Kahler Slater is pleased to submit this updated information to the Urban Design Commission as information required for the project's Final Approval for a hotel to be located along Pinckney Street at Judge Doyle Square. Approvals have been secured from both Plan Commission, City Council, and the UDC (save for a few conditions) which were obtained earlier this year. The outstanding conditions to obtain final approval from the UDC included the following:

JUDGE DOYLE SQUARE

HOTEL DEVELOPMENT | BLOCK 105 | MADISON, WISCONSIN

CITY OF MADISON UDC SUBMITTAL
JULY 28, 2021 (REVISED AUG 26)

A. END WALL DETAILS (PRIOR OPTIONS)

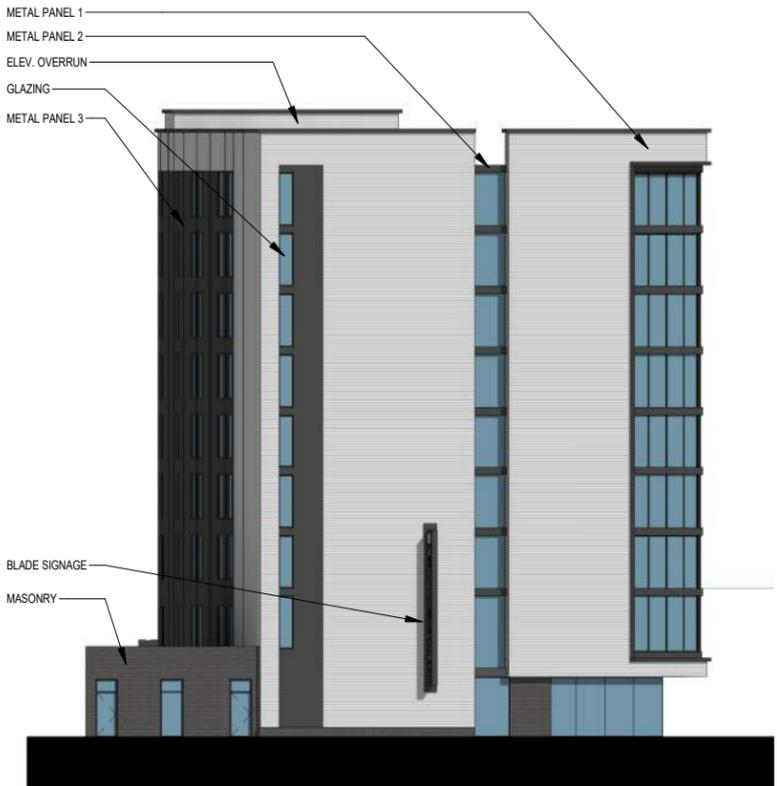
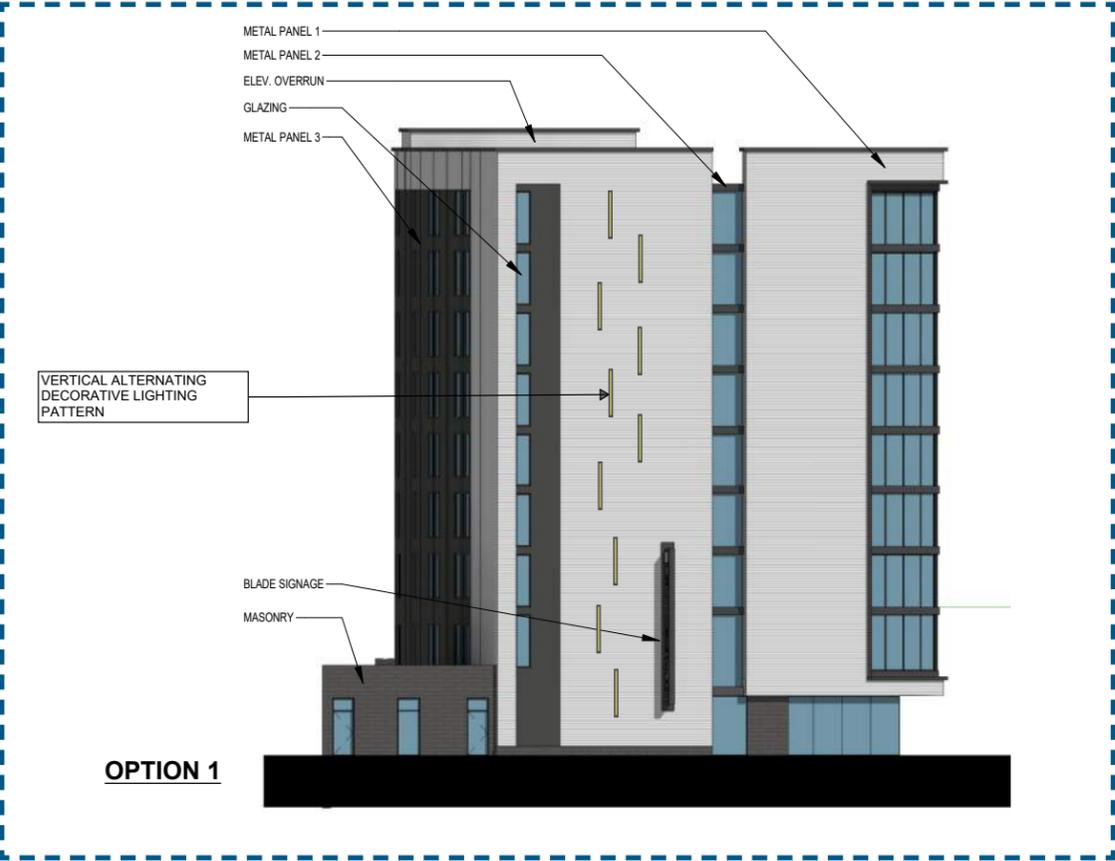
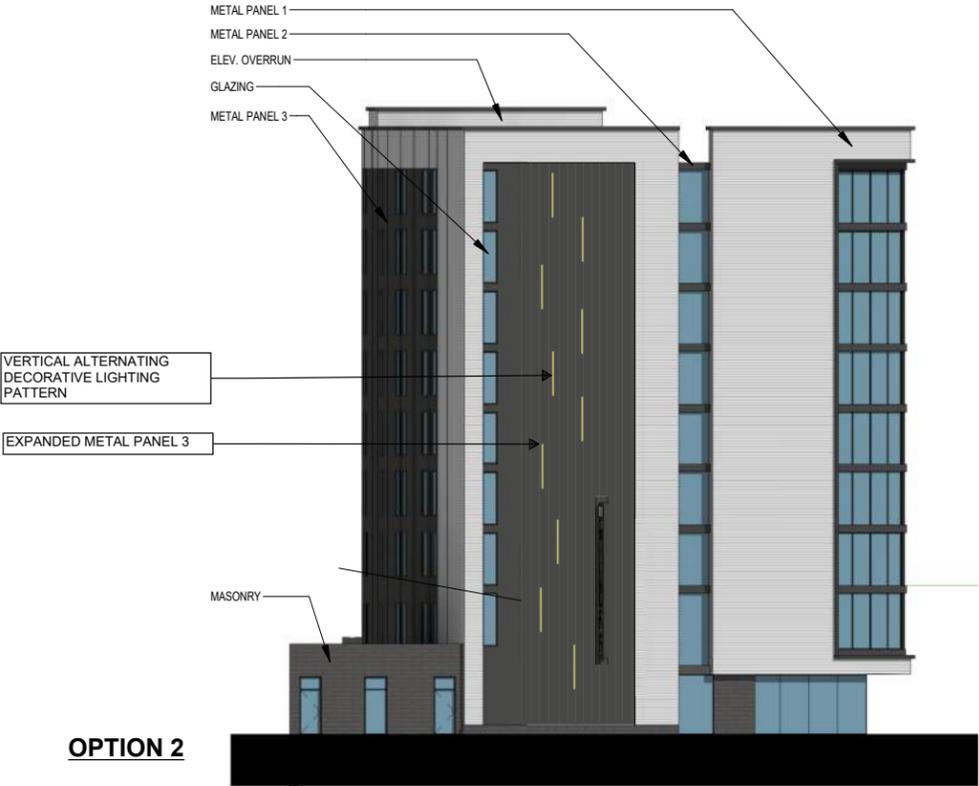
62a. Final details of the end wall leaning towards Option 1.

The design team has explored various options, building off of the concept previously presented in Option 1 referenced above, whereby the Commission's guidance was to incorporate a lighting strategy and not additional materials. The proposed solution is to integrate horizontal accent strip LED lighting within the ribs of the corrugated metal panel in a pattern that steps up the façade to create a dramatic effect.

B. METAL PANEL STRIATION (PROPOSED DETAIL)

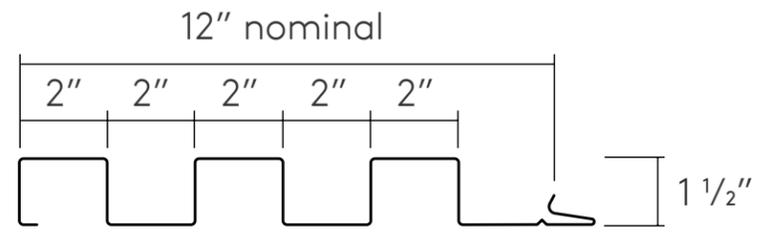
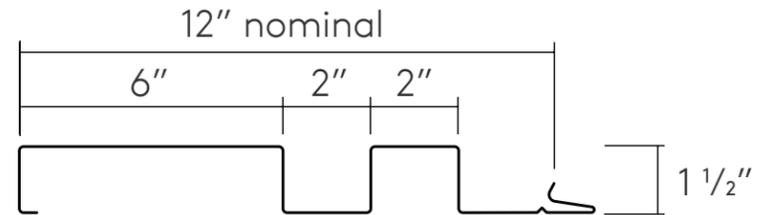
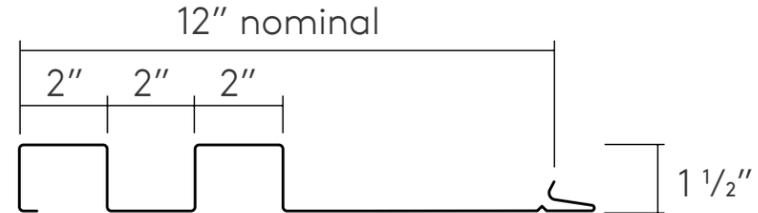
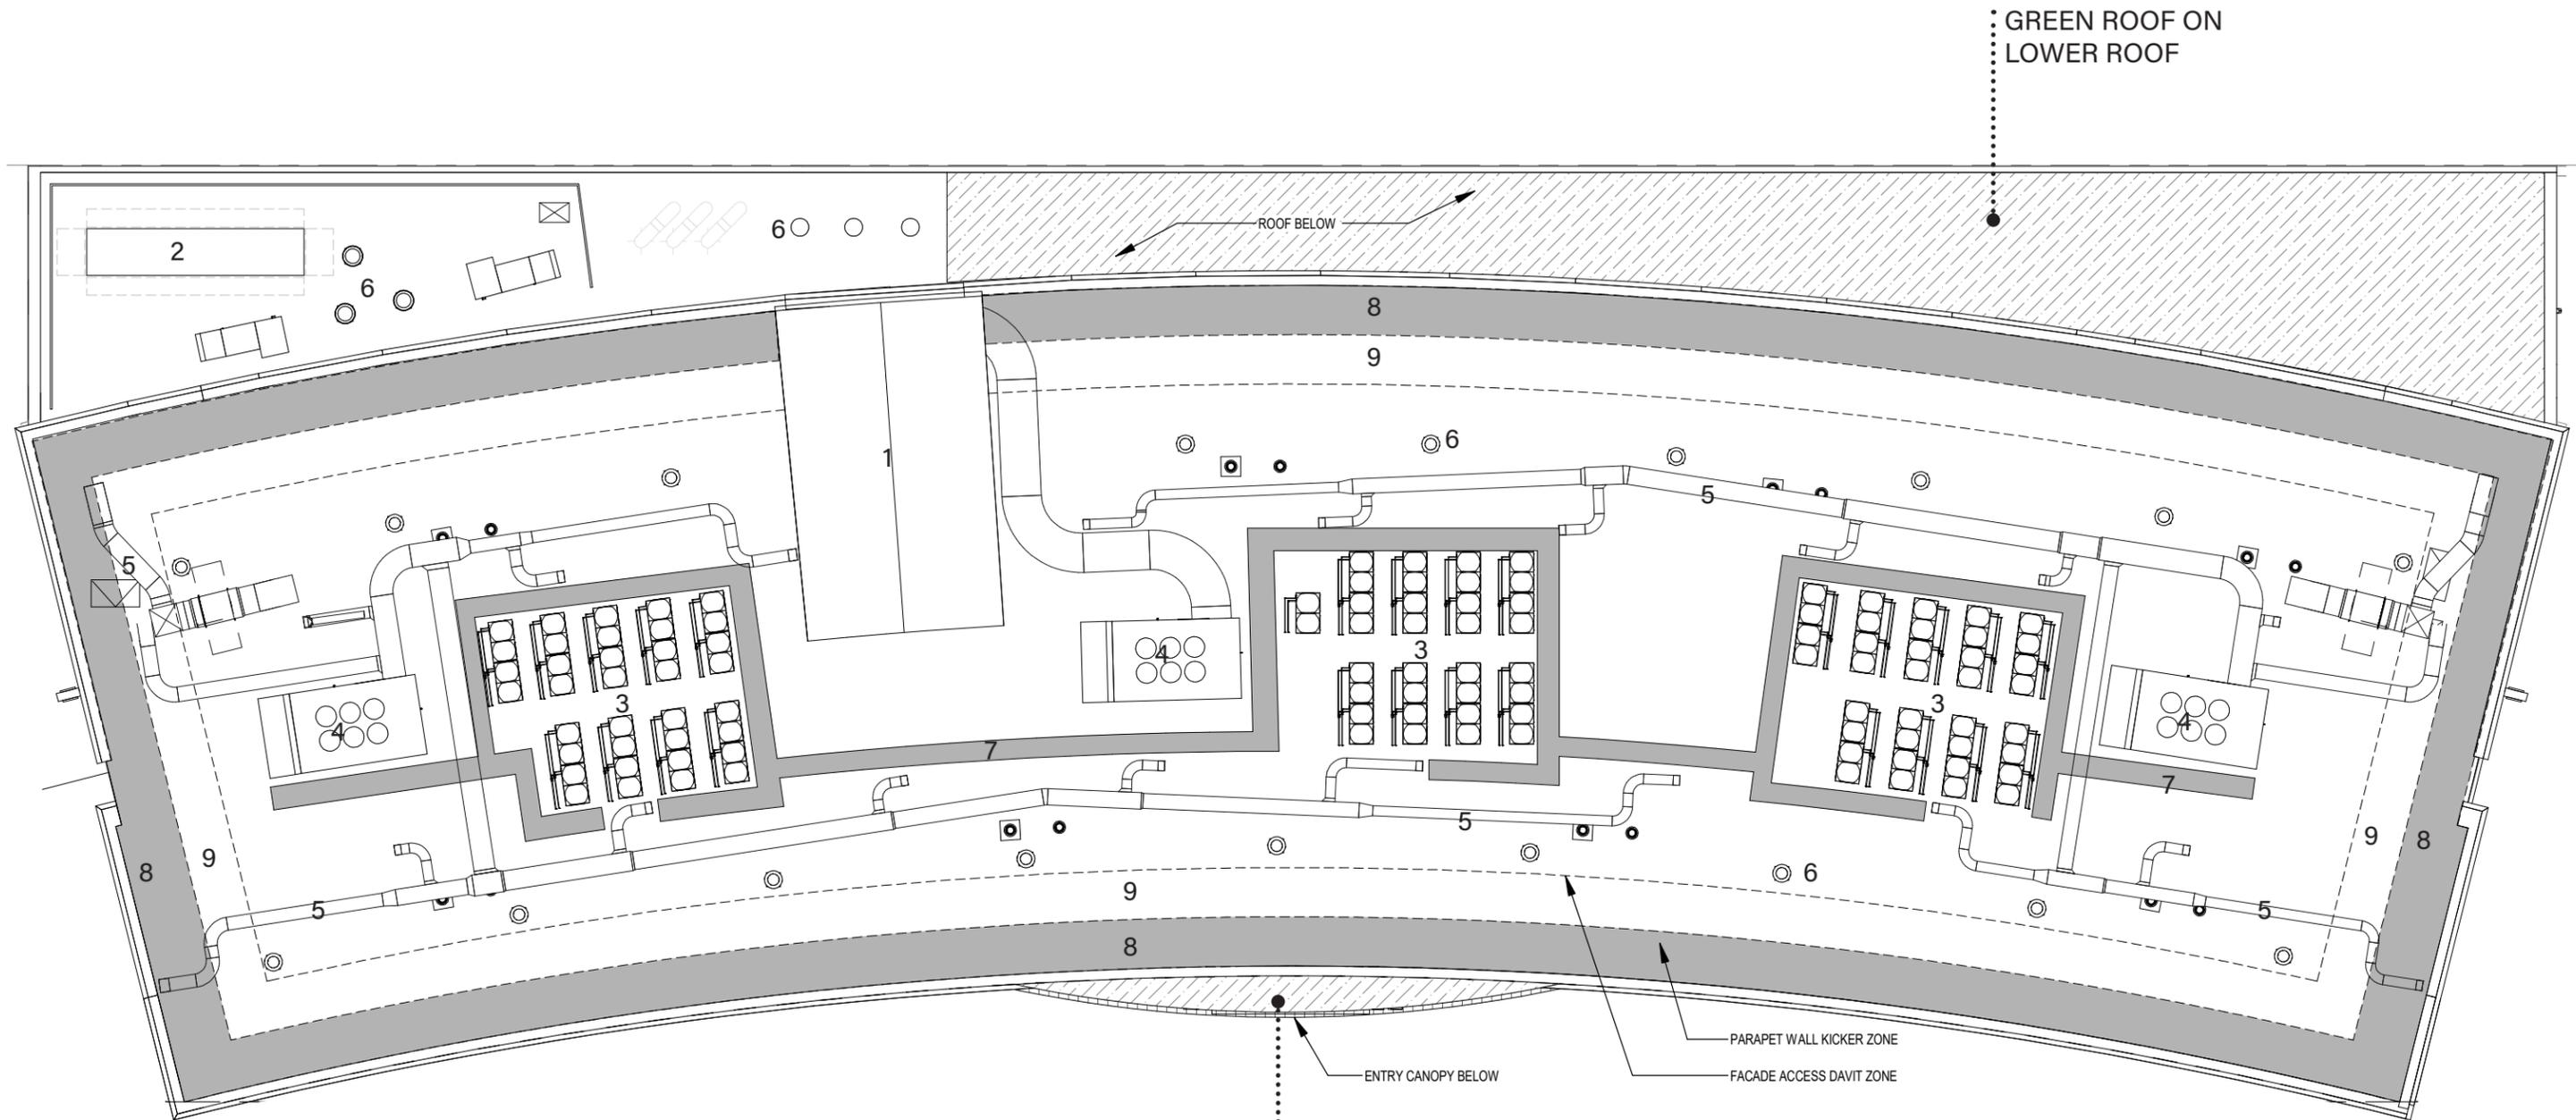
62b. Enlargement and more detailed rendering of the exact metal sheathing and striation.

The proposed metal panel are corrugated painted aluminum with 90 degree bends and come in a range of profiles that can be combined for aesthetic variety. Details of the proposed solution and precedent imagery are included in the submittal.

- PANELS TO BE SET IN A HORIZONTAL ORIENTATION
- PANEL MIX TO BE RANDOMIZED VERTICALLY UP THE FACADE.
- ALL PANELS TO BE THE SAME COLOR.
- MITERED CORNER CONDITION.
- END SEAMS ARE FLUSH.

C. ROOF PLAN (DETAILED LAYOUT)

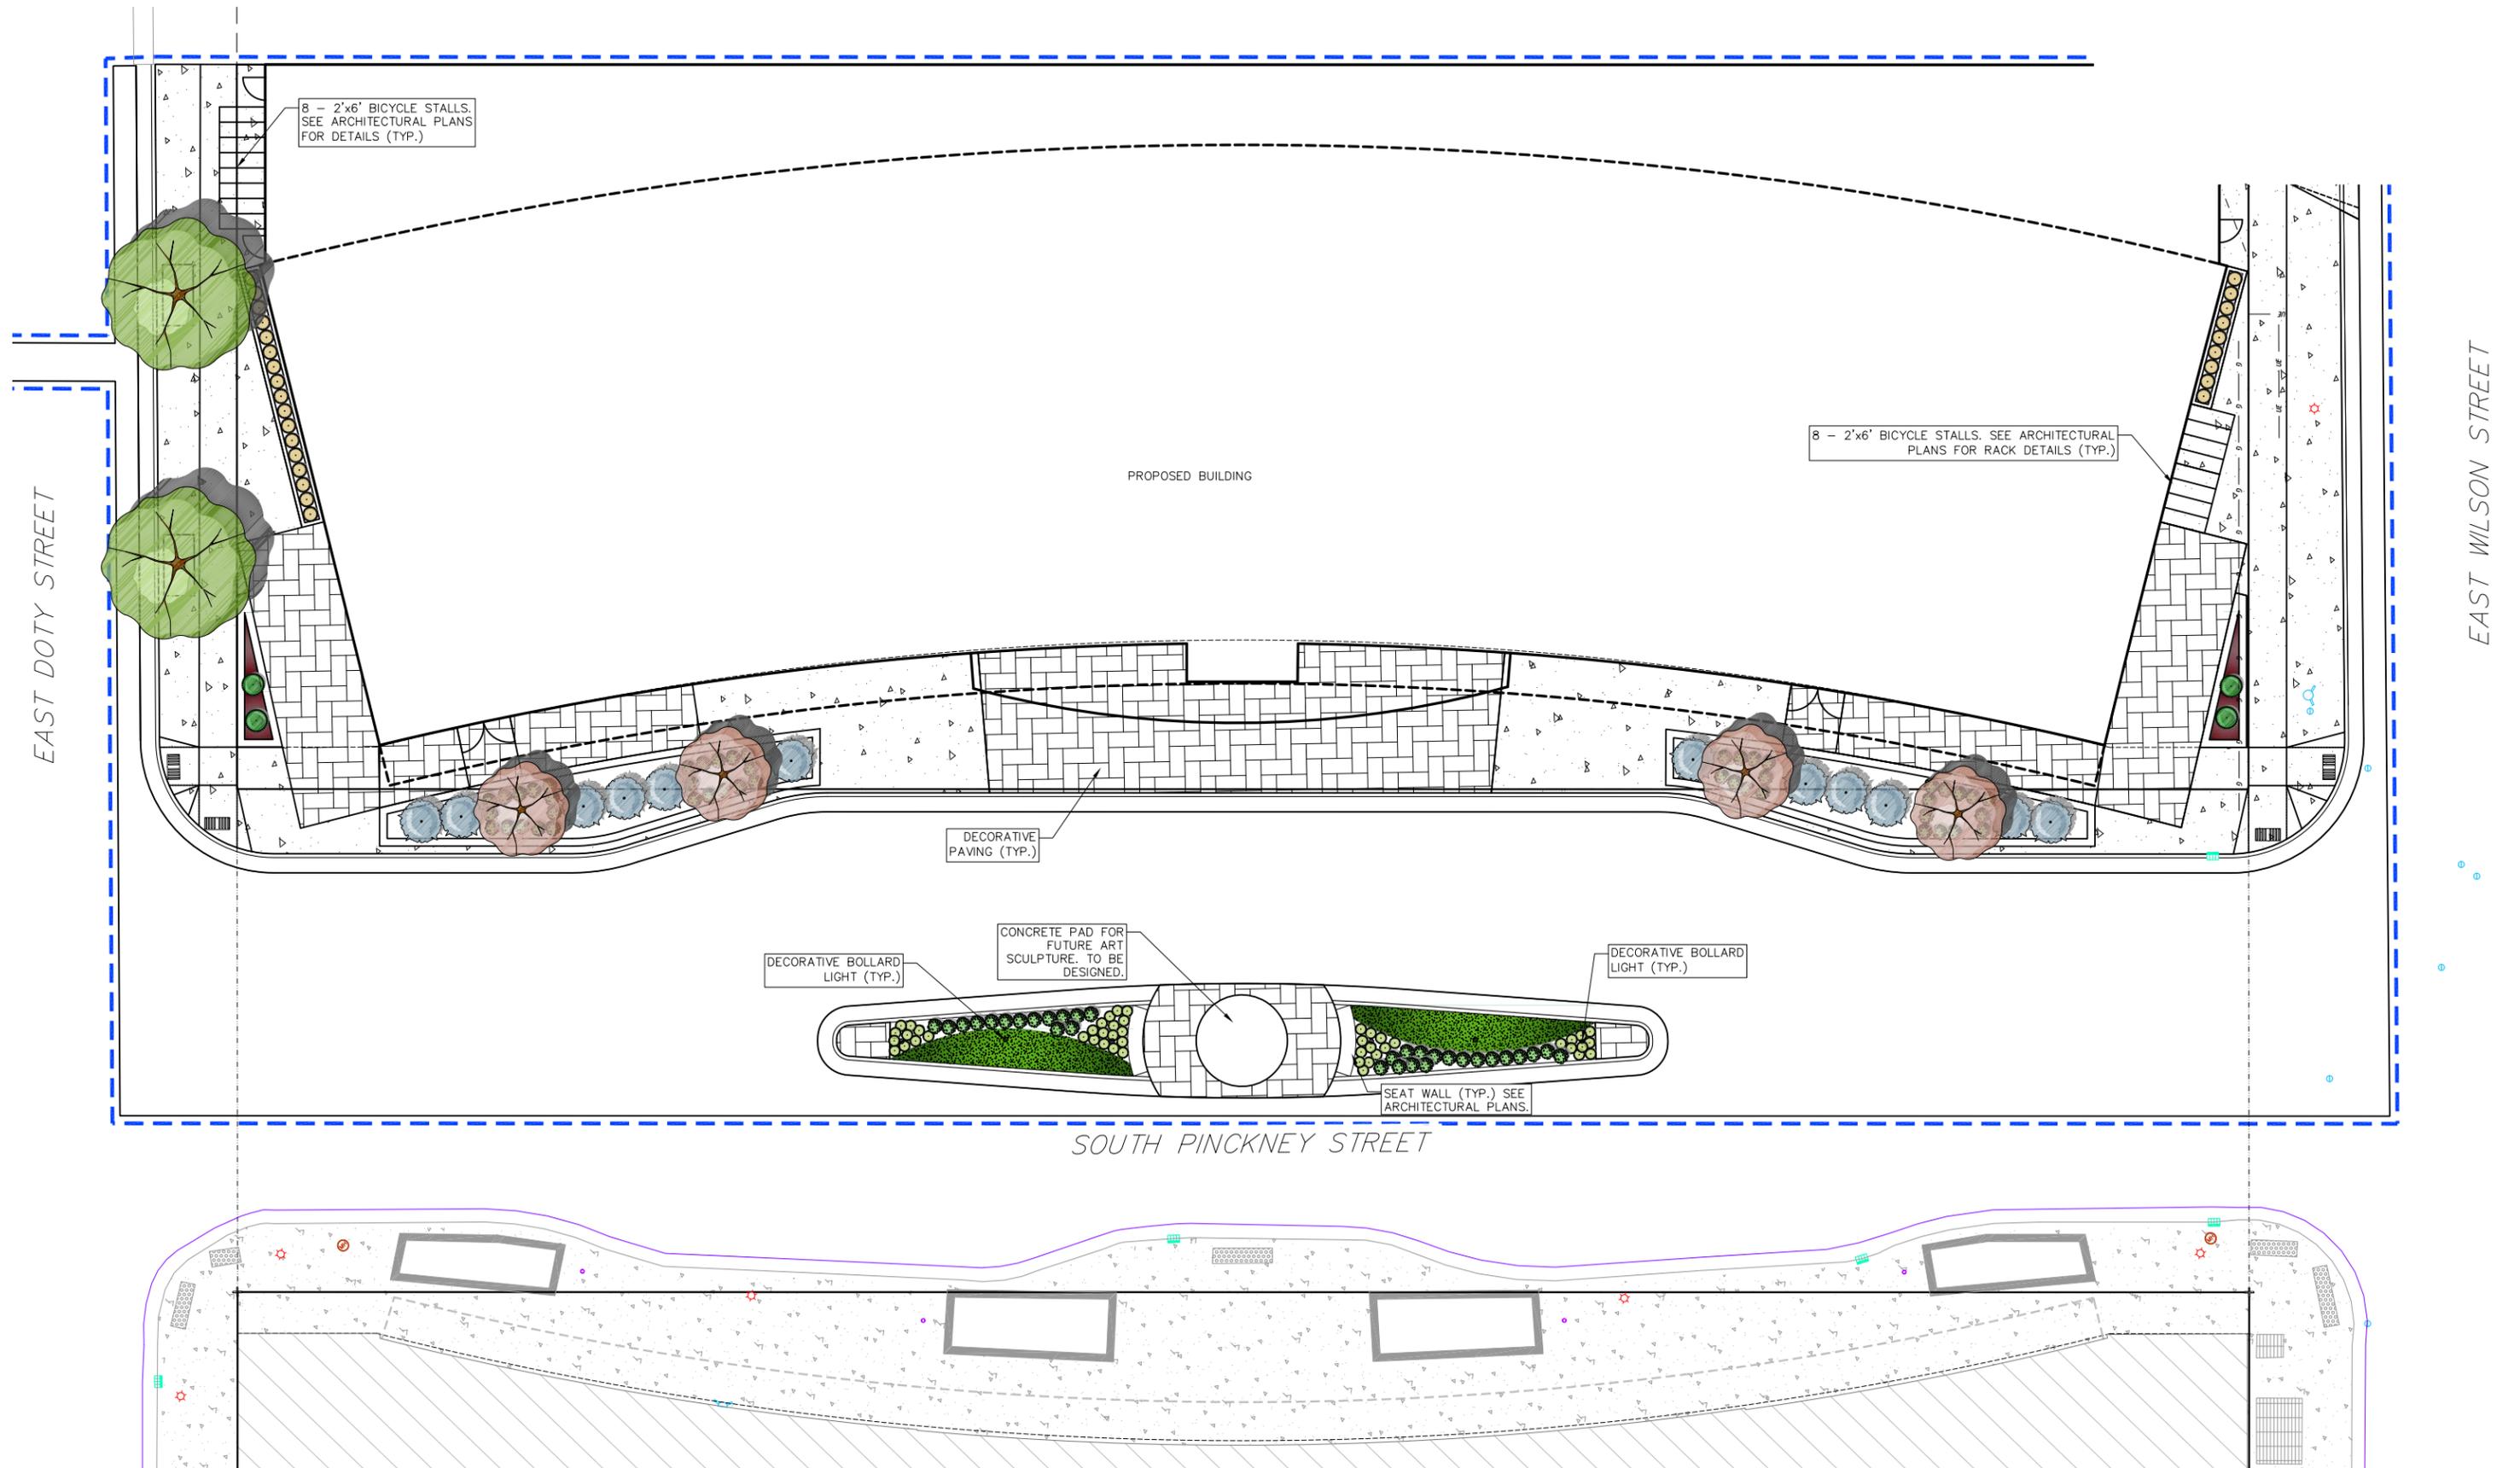
62c. A fully detailed roof plan, including rooftop mechanical screen and other possible components (solar, green roof, etc.).

The design team has been working with engineering consultants to determine the required equipment on the roof. There are structural considerations, maintenance requirements, HVAC equipment, a generator, and numerous exhaust fans and vents. In spite of this, the team has been able to preserve an area on the low roof and canopy for a green roof system.
